SUNDRY NOTICES AND REPORTS ON WELLS

8. Well Name and No.  
Cotton Draw Unit #67

2. Name of Operator  
Devon Energy Production Co., LP

"R-III-P, Solid Plug thru Atoka"

## PROPOSED P&A SCHEMAT

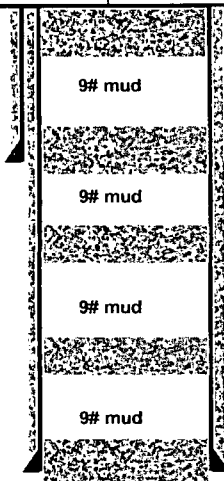
2. Set CIBP @ 13,850'. Spot 145 sx cement on top. Tag TOC. (CTOC @ 12,250'..5-1/2" liner top @ 12,282') WOC Tag. \*

3. Spot 25 sx cement @ 8,300'. (CTOC @ 8,170'. Top of Bone Spring @ 8,300') 8350'

4. Spot 25 sx cement @ 7,940'. (CTOC @ 7,810'. DV Tool @ 7,886') 180' plug. WOC Tag.

5. Cut & pull 7-5/8" casing from 6,620'. Spot 50 sx cement @ 6,670'. Tag TOC. (CTOC @ 6,520') 160' plug WOC Tag

\* Add plug (csg bad). spot cmt from 11780' - 11580'. WOC Tag.

Ground Level Dry Hole Marker Reg.
